**Heckington Fen Wind Farm
S36 Variation Application**

**up to 22 Wind Turbines with a increased rotor diameter
of up to 103 m whilst retaining consented tip height of 125 m**

**Wind Turbine Noise Impact Assessment
Appraisal**

Figure 4 Effect of a "stubby tower" on windshear.

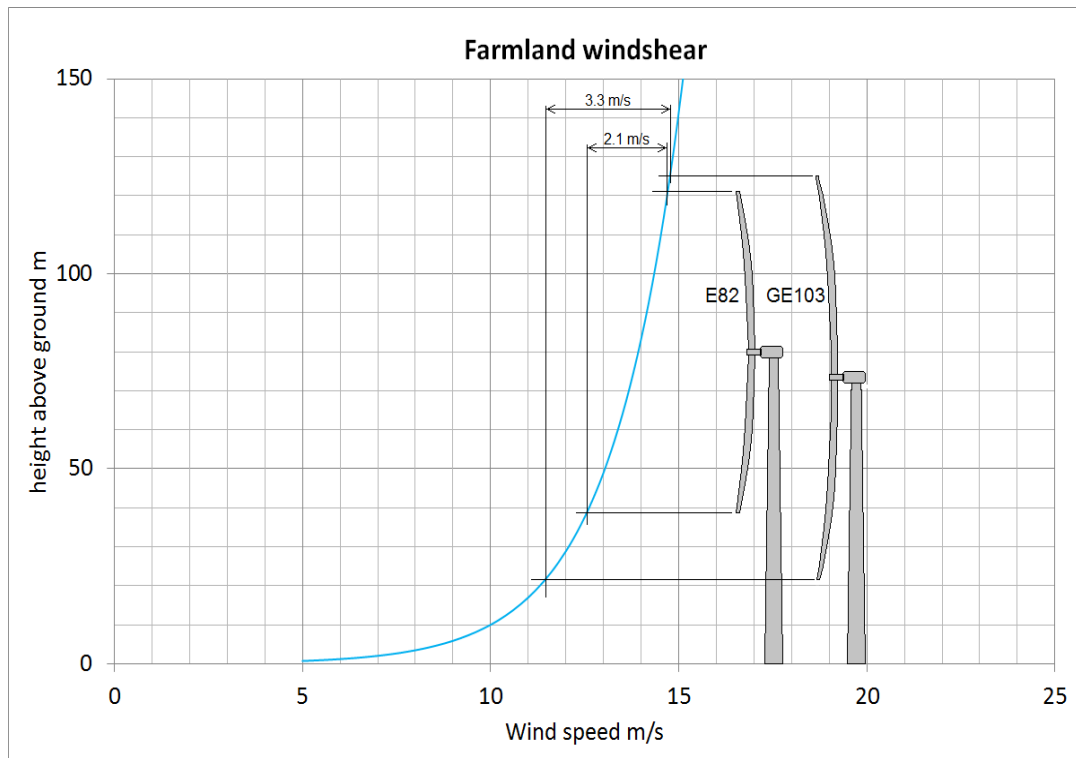
3.2.7 The chart in figure 4 shows, to scale, the vertical variations in wind speed (i.e. the wind shears) over the rotor disc of the originally proposed E82 turbine (2.1 m/s) and the currently proposed GE103 turbine (3.3 m/s, 57% more than for the E82 turbine). A 10 m/s wind speed at 10 m reference height wind speed is assumed, with a roughness length of 0.05 m, as quoted in ETSU-R-97 for “*farmland with some vegetation*”. This value however is based on measurements made during normal working hours, when wind shear is least. As noted above, after sunset wind shear can be much greater. I will now explain why high wind shear implies high levels of low frequency wind turbine noise.

Figure 5: EN3 guidance on wind turbine spacing.

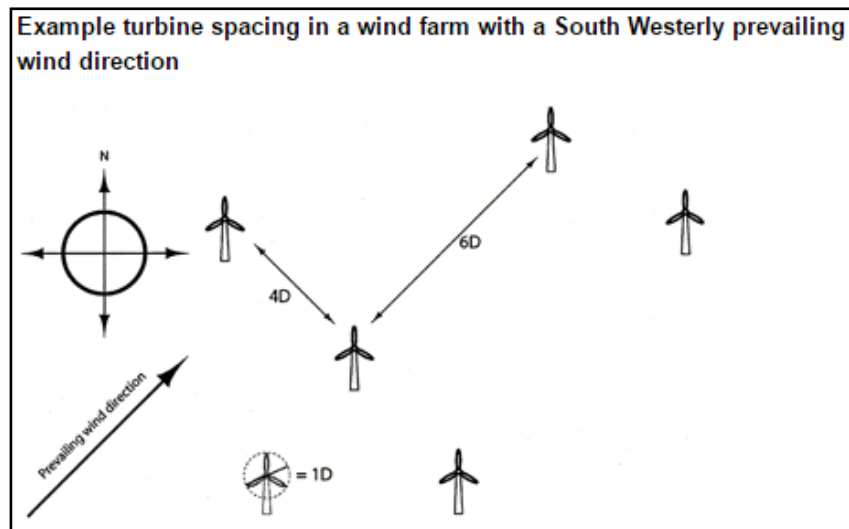
4.2.1 The proposed turbine positions are unusually closely spaced; planning guidance (EN3) proposes 4D x 6D (crosswind x downwind, where D is the rotor diameter). With the proposed 103 m rotor diameter, downwind spacings around 450 m and crosswind spacings around 300 m the guidance proposal of 4D x 6D has been abandoned in favour of 2.9D x 4.4D, a turbine density 1.9 times that of the recommended spacings. There are two consequences of this; the mean wind farm output power is significantly reduced, which does not concern me here, but the turbine noise emission power is significantly increased, due to inflow turbulence, which does concern me here.

4.2.2 The reason that the UK Government Planning Portal advises the 4D x 6D spacing of figure 5 as a minimum is that a turbine operating in the turbulent wake of another has a lower electrical output and a higher noise output than a turbine in clean airflow. Whilst the 4D x 6D spacing is advised in EN3 rather than mandated, the increased inflow turbulence characteristic of closer spacings invalidates turbine manufacturer's operational noise warranties. Published generation and noise data, being based on measurements of single turbines, can no longer be relied upon. I have not allowed for this in my NIA, but I would expect some margin below the ETSU limit to be reserved to accommodate it.

Figure 6: Applicant's derived background noise polynomials for all six background noise surveys.

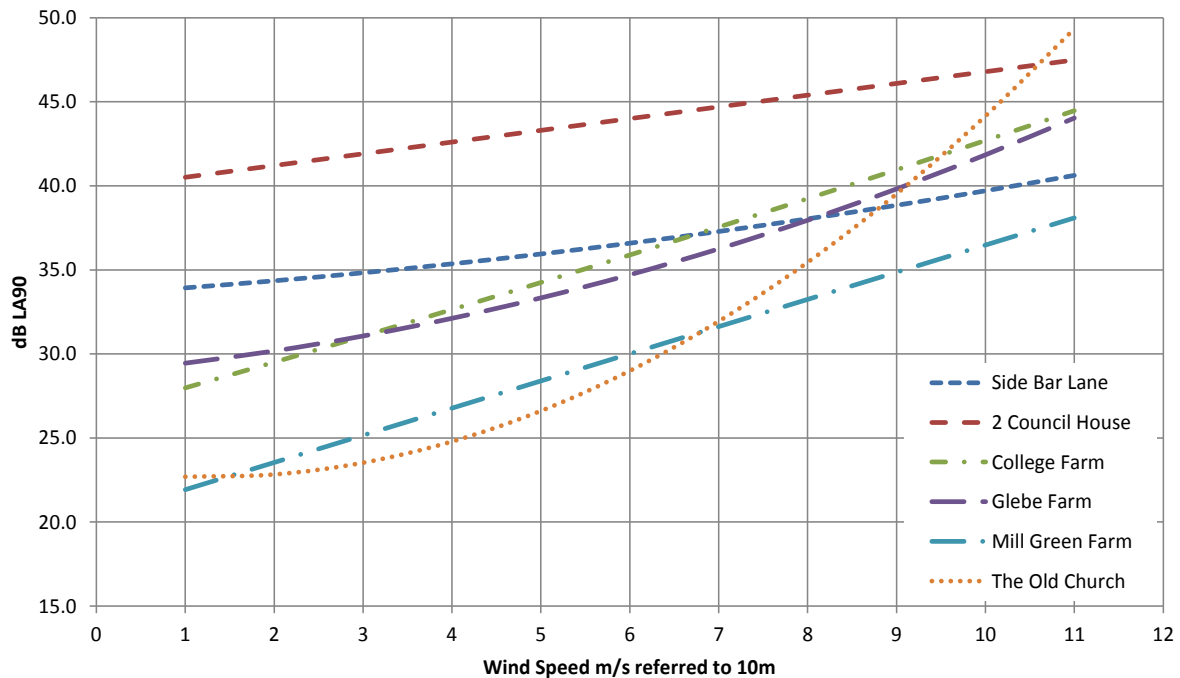
- 5.2.1 In the absence of the applicant's raw noise data is instructive to compare the measured noise levels at the six surveyed receptors, plotted in figure 6 above from the applicant's chart polynomial coefficients. With the single exception of The Old Church there is relatively little increase (5 to 12 dB) in the background noise level from 4 m/s (cut in wind speed) to 11 m/s; at The Old Church however the increase is 25 dB. The reason for this is explained in §4.3 below; essentially it is because the chosen microphone position was too close to trees and hedges.

5.5.11 For the avoidance of any doubt that the applicant’s statement quoted above is disturbingly wrong I refer again to my chart of polynomials in Figure. This background noise survey is deeply flawed, and therefore invalid for 2 Council Houses itself. It is also invalid for use as a proxy for any of the other six of the receptors listed above, and would have been for four of them even if it had been correctly executed.

Figure 16: Enercon E82 turbine proposed in original application compared with GE 103 turbine proposed in variation application; both are shown to the same scale.

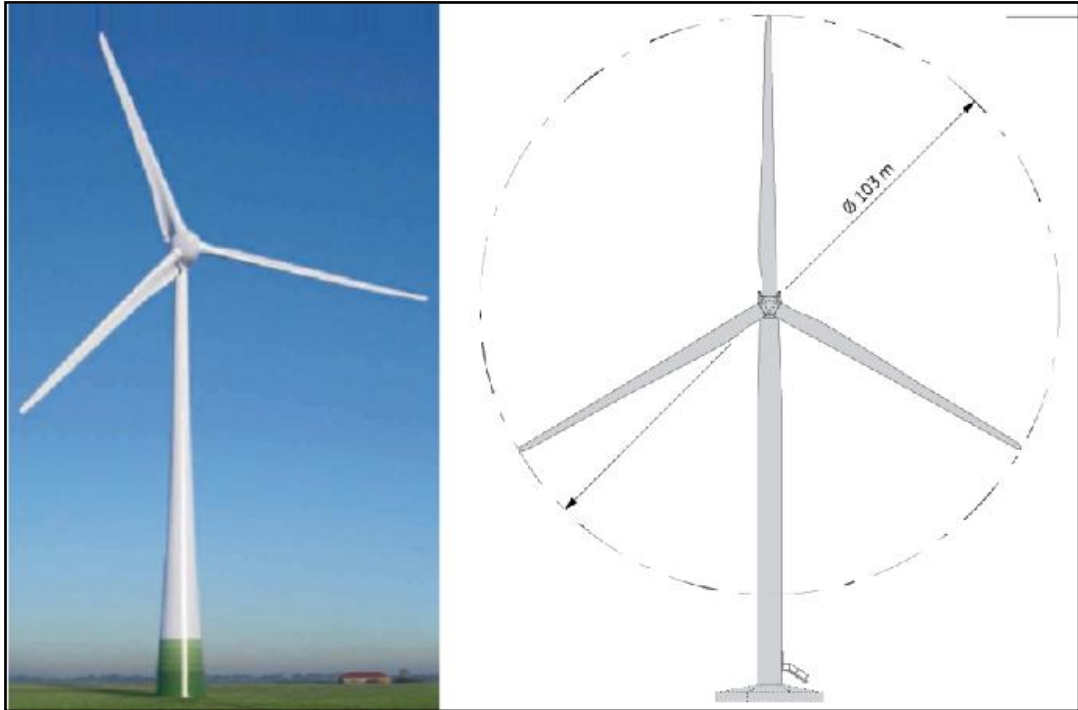
- 7.2.1 There are three factors associated with the proposed wind farm which will significantly affect its noise emissions, but to an extent that is difficult to quantify. The first is the "stubby tower" design; this is a major concern for the variation application, but is also relevant for the original design, as it will be seen in the appended turbine noise specification that Enercon offer the E82-2.3MW turbine with a range of five very different hub heights. These are illustrated to scale in figure 15. Thus the original application had already proposed the shortest tower available, at 78 m hub height, which has the highest probability of stall at blade zenith with the increased aerodynamic and very low frequency noise that this implies. Figure 16 shows the considerable difference between the original E82 turbine and the General Electric GEs 103 turbine proposed for the variation.
